ENGINE - FUEL AND CONTROL - FUEL - REPLACE THE FUEL DIVERTER AND RETURN VALVE ATTACHING WASHER - CATEGORY CODE 4 - MOD.ENG-73-0002

V2500-ENG-73-0002

Rework of the fuel diverter and return valve attaching washer  
Fig.1

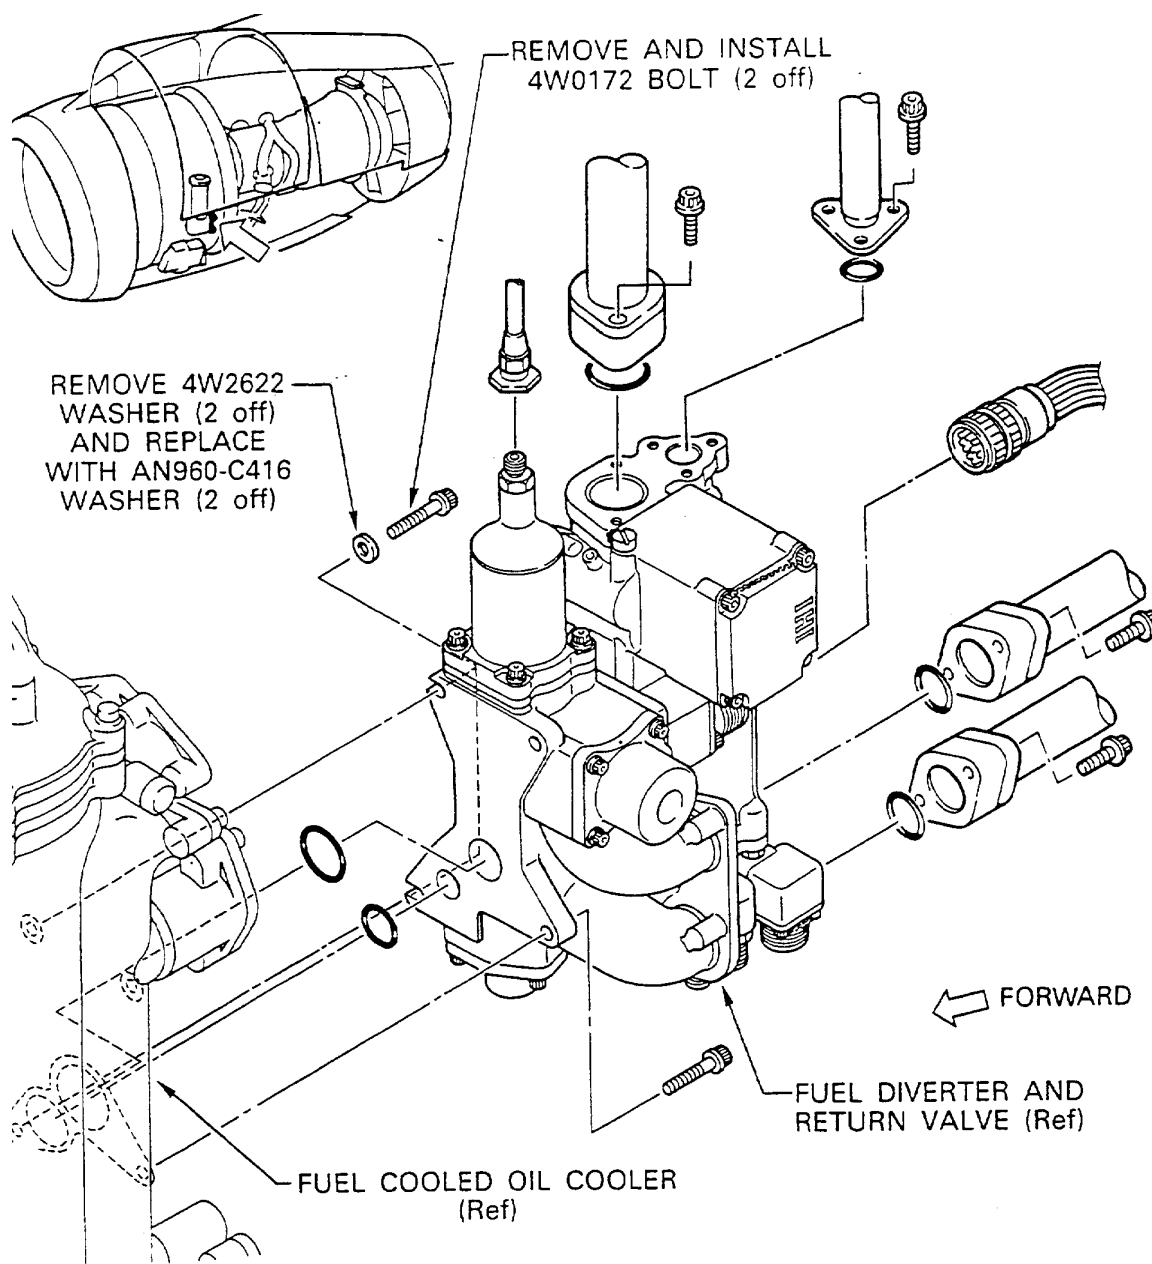
Insufficient clearance may occur between the Fuel Diverter and Return Valve attaching washers and the Fuel Diverter and return Valve housing.

Analysis has shown that too large outside diameter of the attaching washers could be the cause of this condition.

(a) The washers which attach the Fuel Diverter and return Valve have been changed from PN4W2622 to PN AN960-C416 (See Figure 1).

- (1) Remove two PN4W0172, Bolts and two PN4W2622, Washers from the Fuel Diverter and return Valve and Fuel Cooled Oil Cooler (FCOC) (Refer to Figure 1 and the Aircraft Maintenance Manual, 73-13-42, Removal/Installation).
- (2) Install two new PN AN960-C416, Washers and two PN4W0172, Bolts to the Fuel Diverter and return Valve and the FCOC (refer to Figure 1 and the Aircraft Maintenance Manual, 73-13-42, removal/Installation).
- (3) Torque the two bolts to 85-95 lbfin (9,60-10,73 Nm) (Refer to Aircraft Maintenance manual, 70-23-11, Torque Tightening technique).
